Addendum No. 2

Date: June 23, 2025

Project: City of South Padre Island Marisol (Laguna Madre) Boat Ramp Construction
ITB 2025-SL01
LJA Project No. C275-21184

BOAT RAMP PLAN & PROFILE

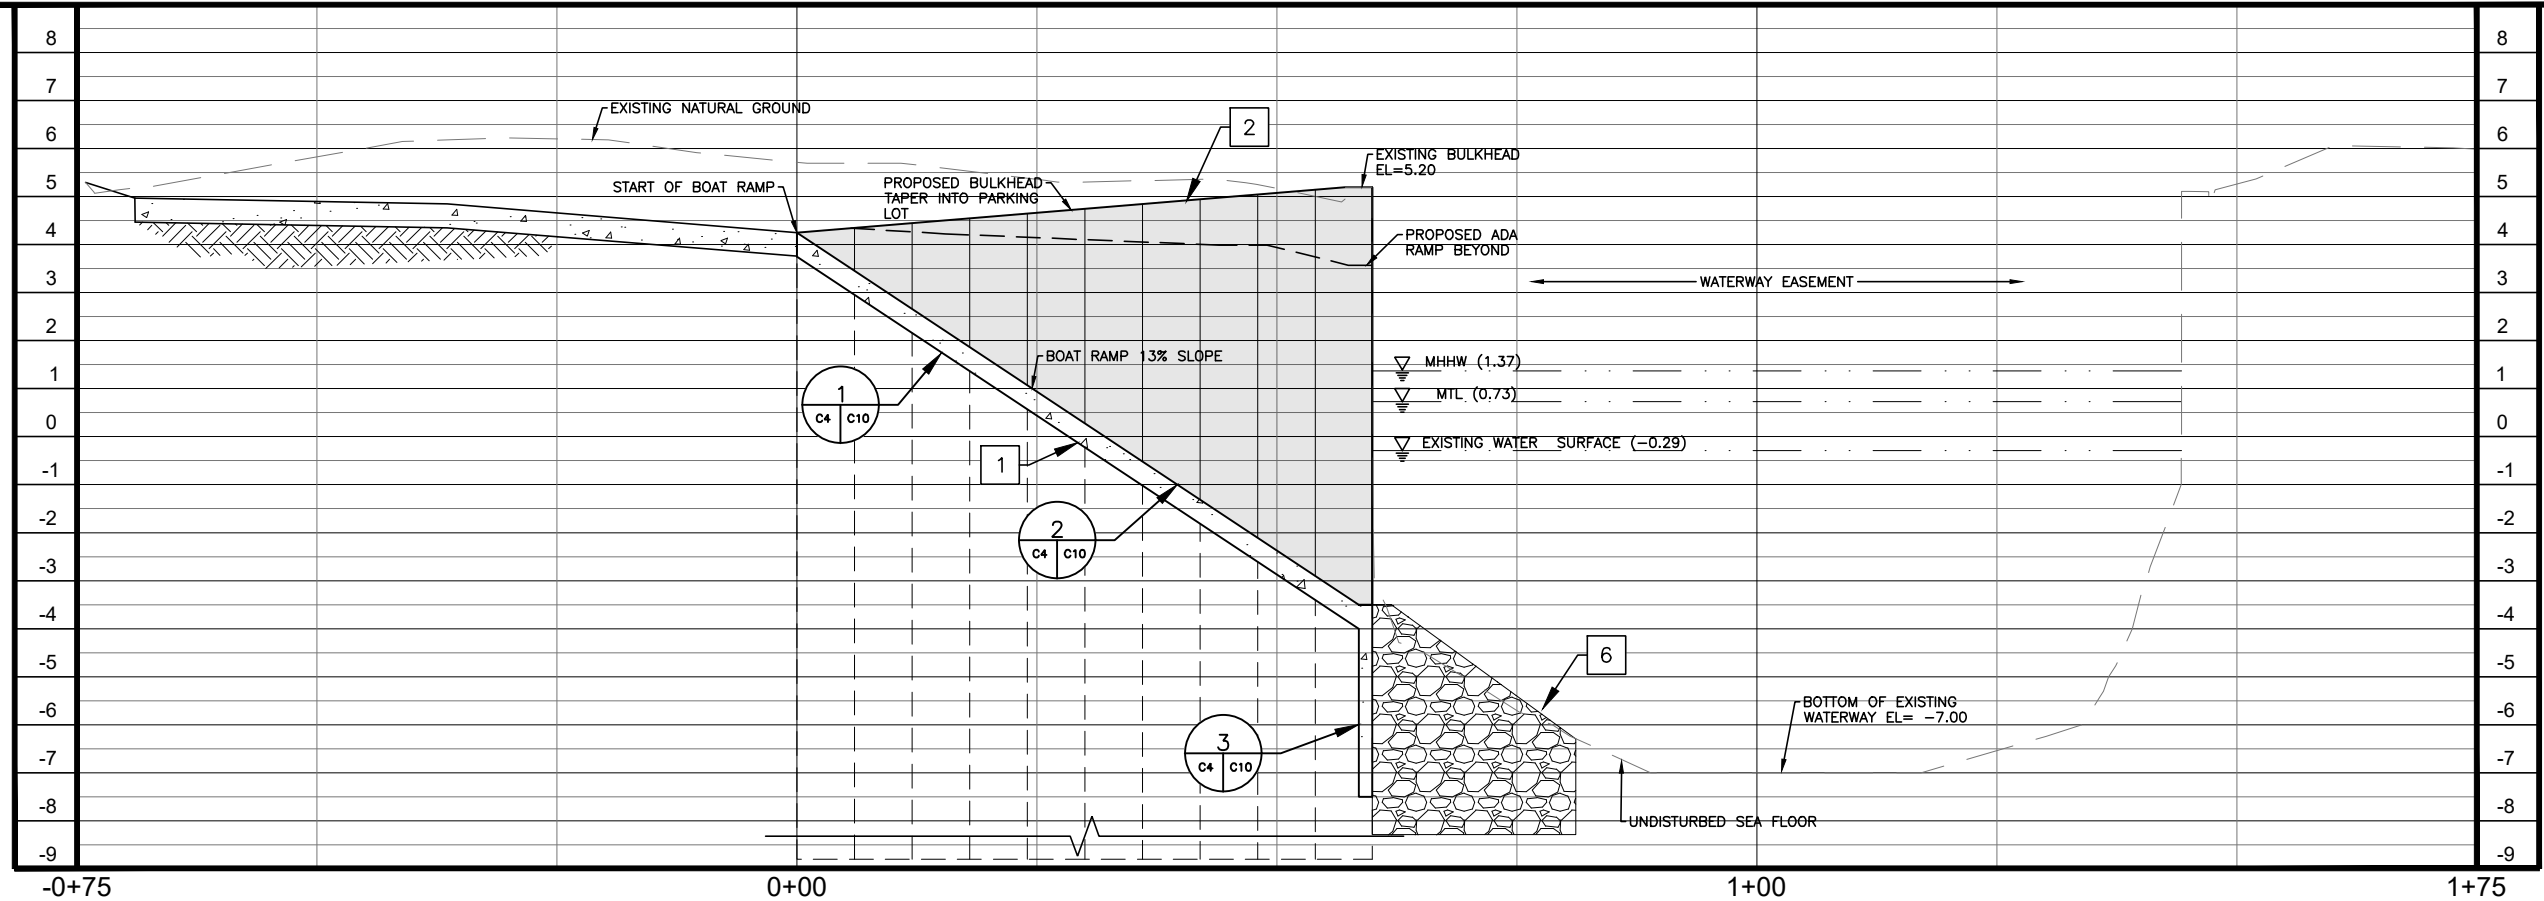
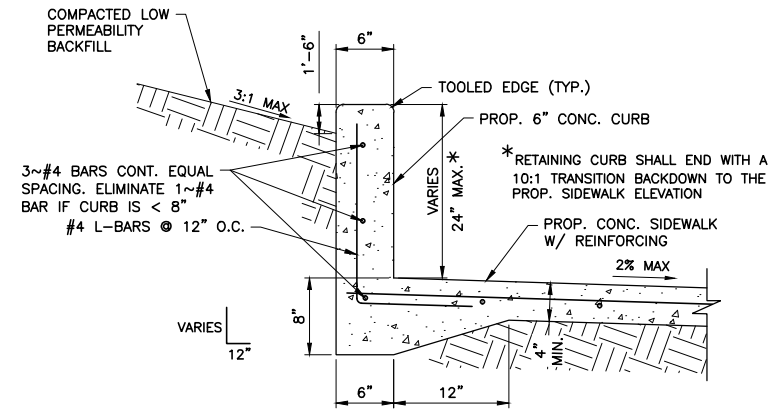
- D. Question 4: Will the tie back dead man require reinforcement? The dead man appears to be deep. Please clarify.

Answer 4: **Tie backs and dead man anchors will no longer be required on this project. Tidewall™ TW95 (or approved equal) vinyl sheets piles have been changed to Nucor PZ 27 (or approved equal), cantilever, steel sheet piles. See revised proposal and plan sheets as part of this addendum.**

| 1 | PROPOSED 133 SY OF 6" CONCRETE BOAT RAMP (SEE SHEET C10 & C11 FOR DETAILS). | 4 | PROPOSED 5 LF OF STEEL SHEET PILE BULKHEAD EL= 5.20 (SEE SHEET C11 FOR DETAILS) |
| 3 | PROPOSED 50 LF OF STEEL SHEET PILE BULKHEAD TAPERED FROM EL: 5.20 TO 4.25 (SEE SHEET C11 FOR DETAILS) | 6 | PROPOSED 36 CY OF ROCK RIPRAP (SEE DETAIL 1 SHEET C10 FOR DETAILS) |

7
C2 C11
BULKHEAD
NOT TO SCALE

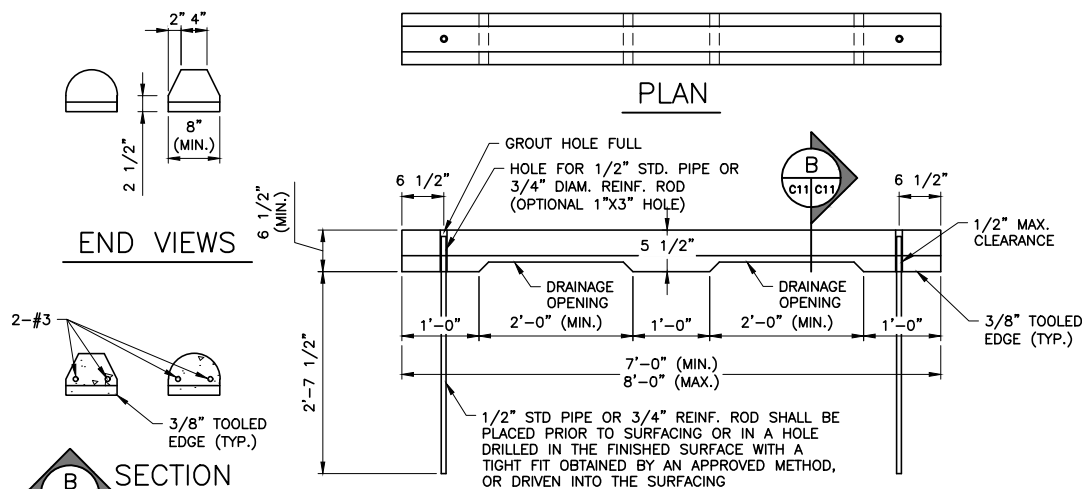
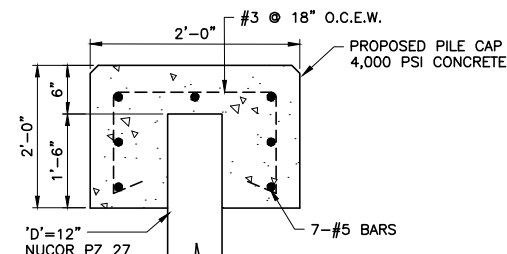
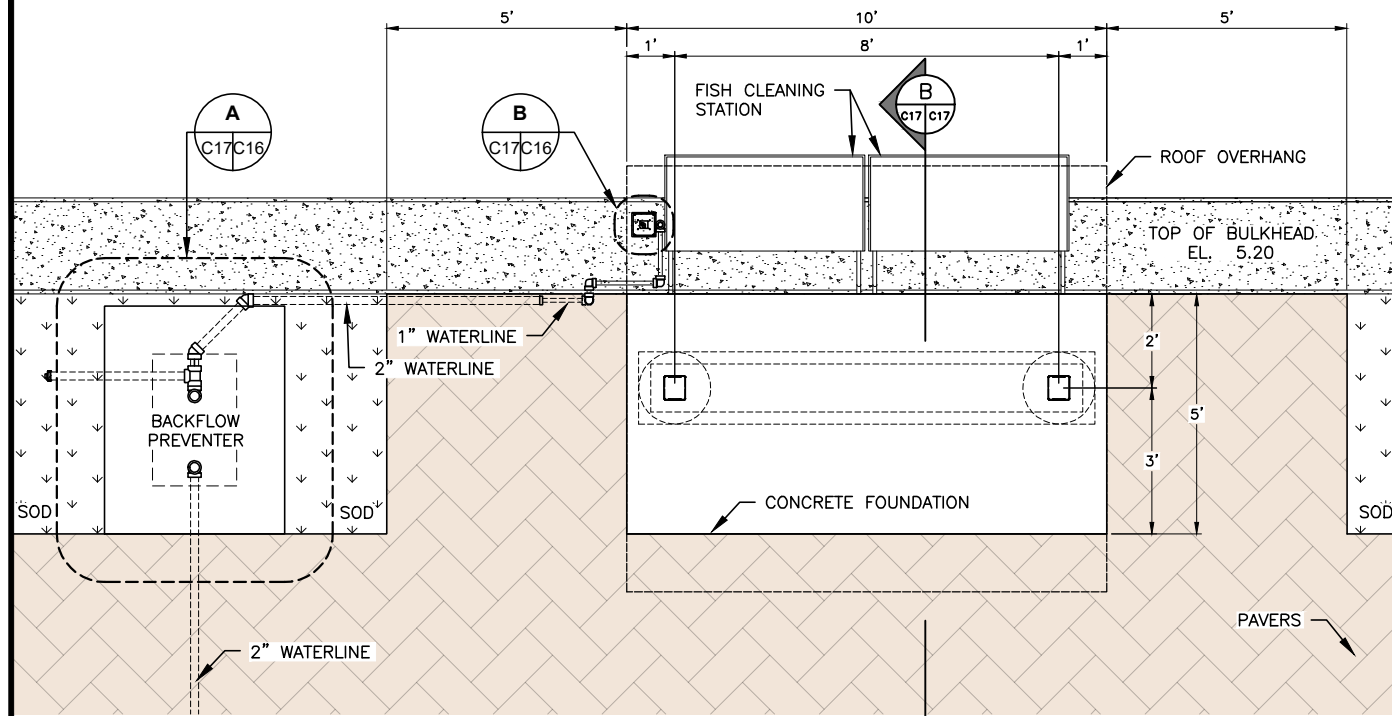
- E. Question 5: The ADA ramp and pavers appear to conflict with the tieback rods for the boat ramp bulkhead. Please provide details and clarify

Answer 5: **This conflict no longer exists as the Tidewall™ TW95 (or approved equal) vinyl sheets piles have been changed to Nucor PZ 27 (or**

approved equal), cantilever, steel sheet piles. See revised proposal and plan sheets as part of this addendum.

SHEET PILE NOTE:
1. NUCOR PZ 27 STEEL SHEET PILE (OR APPROVED EQUAL).

FISH CLEANING STATION

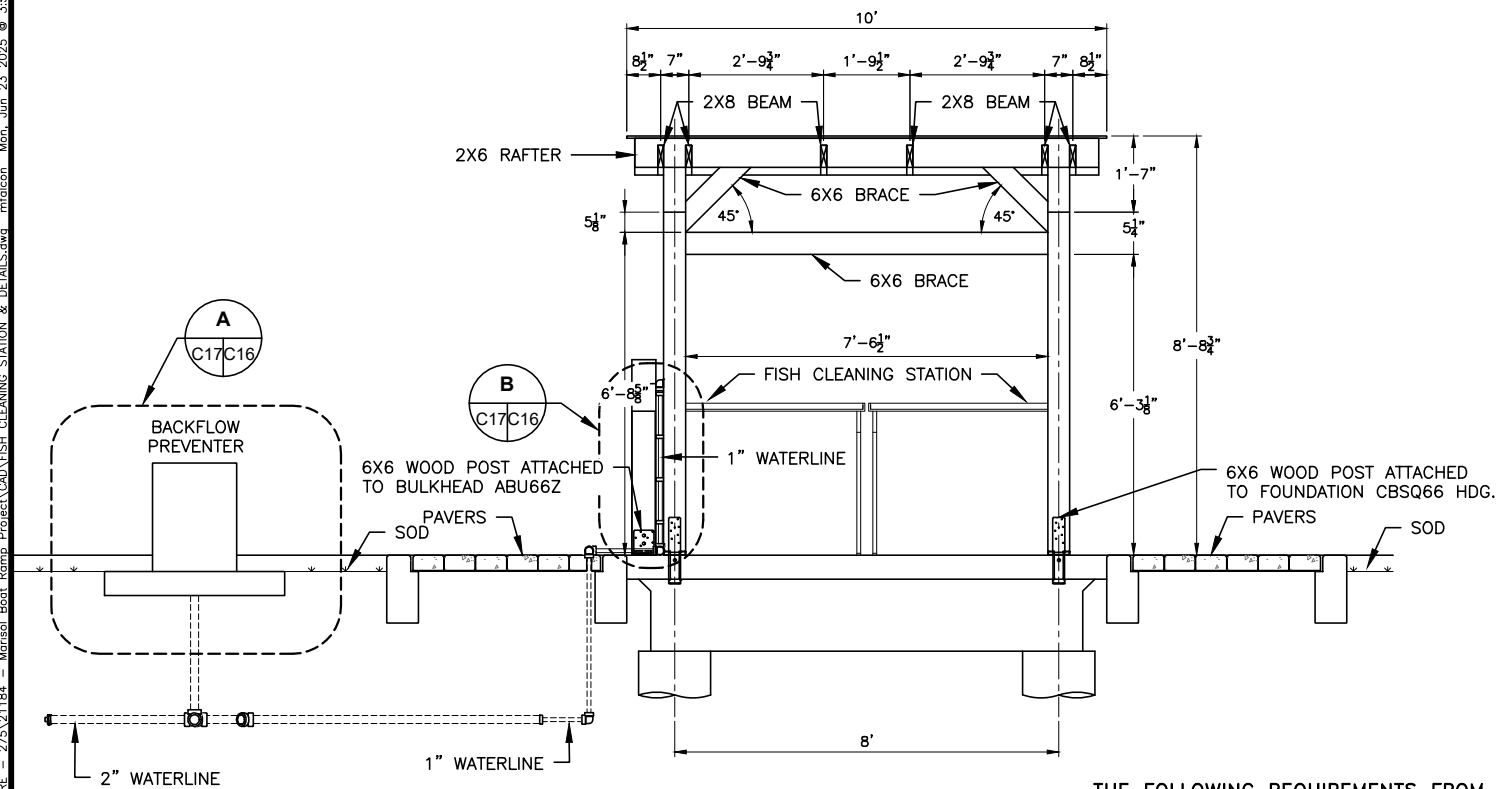
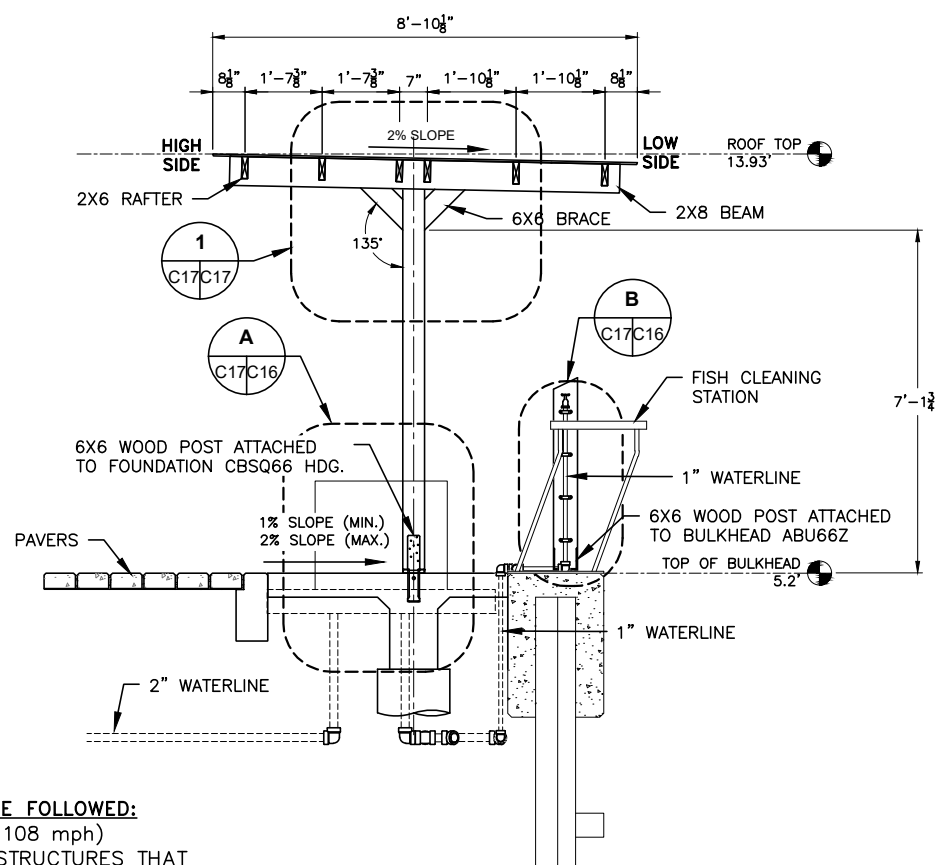
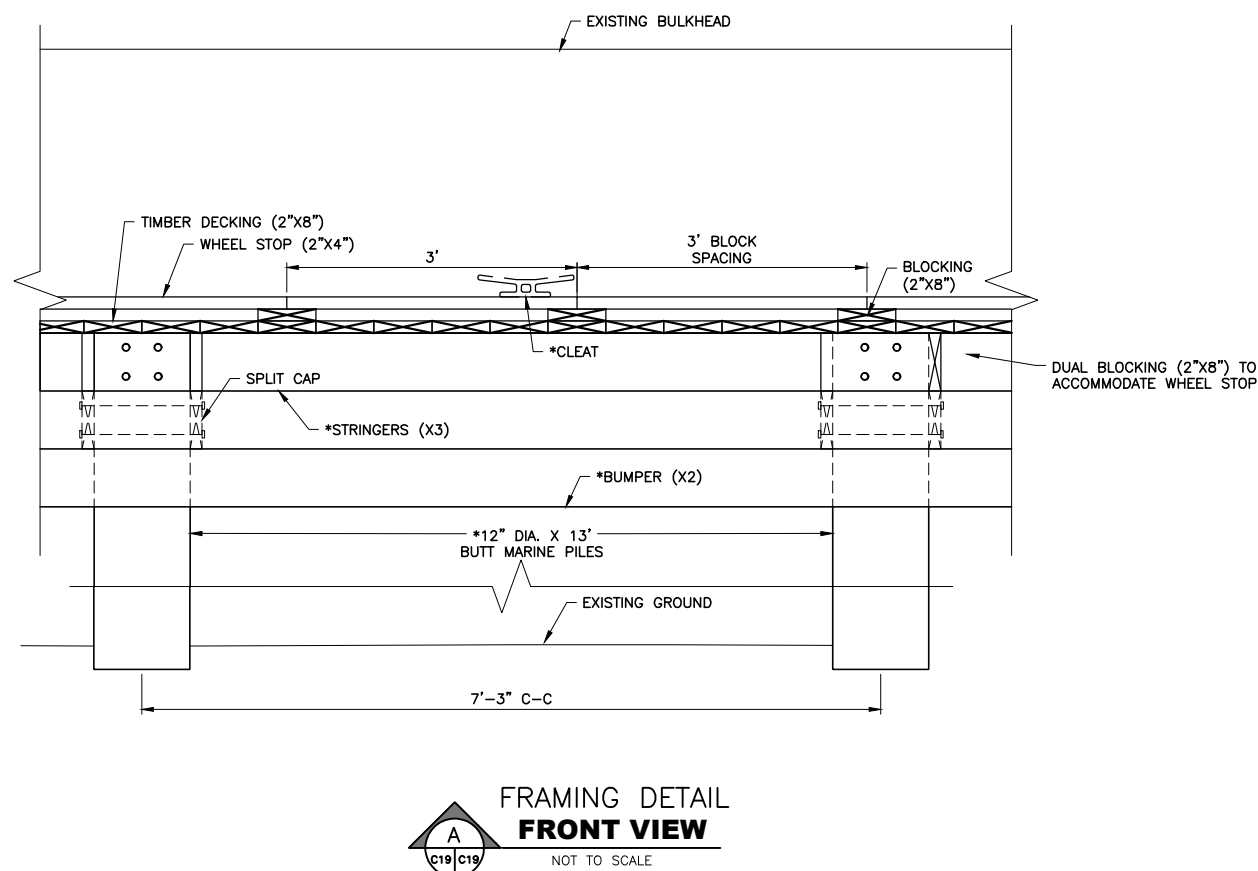
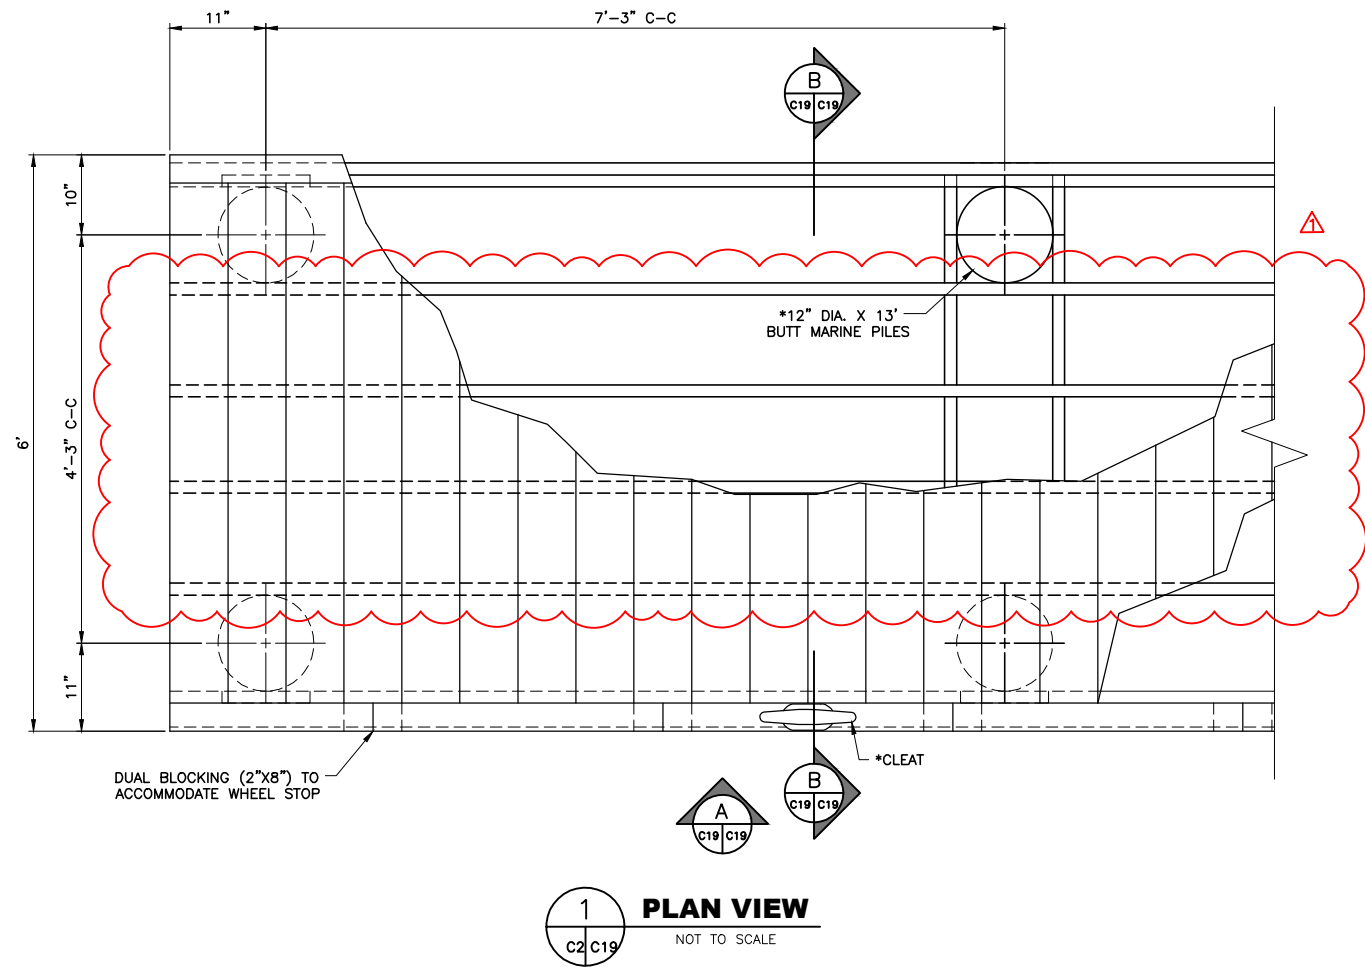
- A. Question 1: In the dock and fish cleaning station plans none of the hardware is detailed other than "All hardware to be Stainless Steel". What are the sizes of the bolts, washers, lock washers? Galvanized or Stainless Steel?

- C. Question 3: For the fish cleaning station hurricane ties are mentioned in the notes but are not shown in the plans or details. Do you want to use joist hangers, or hurricane ties, or both?

Answer 1: **Please see revised sheet C17, as part of this addendum, and specifications 061000 ROUGH CARPENTRY and 067300 COMPOSITE DECKING as part of ITB 2025-SL01.**

Answer 3: **Both hurricane ties and joist hangers are required per notes and details on revised plan sheet C17, as part of this addendum, and specification 061000 ROUGH CARPENTRY as part of ITB 2025-SL01.**

1. ALL HURRICANE TIES SHALL BE SIMPSON STRONG-TIE STAINLESS STEEL TYPE 316 OR APPROVED EQUAL. INSTALL PER MANUFACTURE'S RECOMMENDATIONS.
2. ROOF SHEATHING NAILS WILL BE 10D STAINLESS STEEL NAILS AT 4" ON CENTER ALONG EDGE AND 6" ON CENTER AT INTERIOR SUPPORTS.
3. ALL 10D STAINLESS STEEL NAILS TO MEET MINIMUM LENGTH AT 3" AND SHANK DIAMETER AT 0.148"
4. PROVIDE PLYWOOD FILLER AS REQUIRED TO BE FLUSH WITH WOOD POST.

REMOVED ITB TO CONCLUDE WITH BID YEAR AND UPDATED DETAILS ON FISH CLEANING STATION

DOCK DETAILS

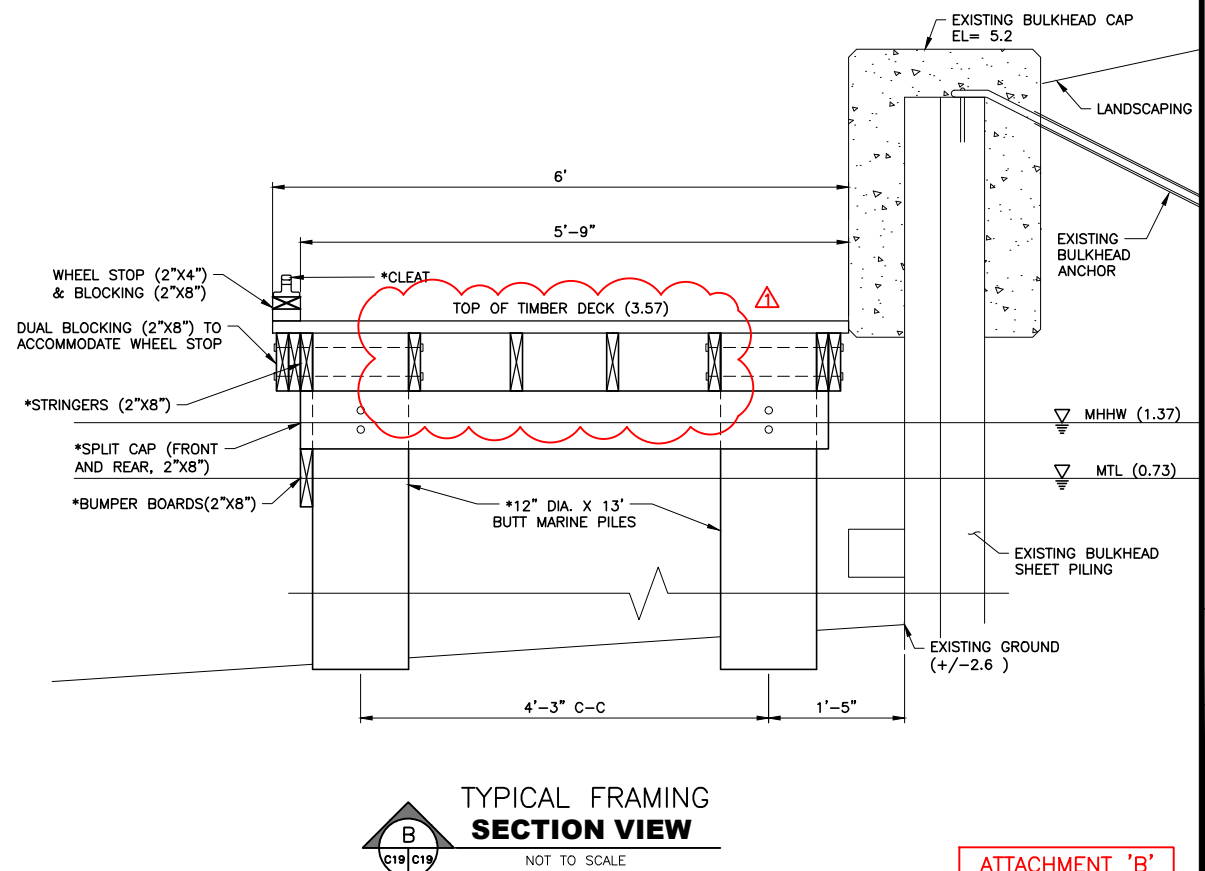
- B. Question 2: For the dock, is it the intention to have 3 stringers in the front, 1 in the middle, and 2 in the rear?

Answer 2: **Please see revised sheet C19, as part of this addendum, adding stringers to the middle part of the attending dock.**
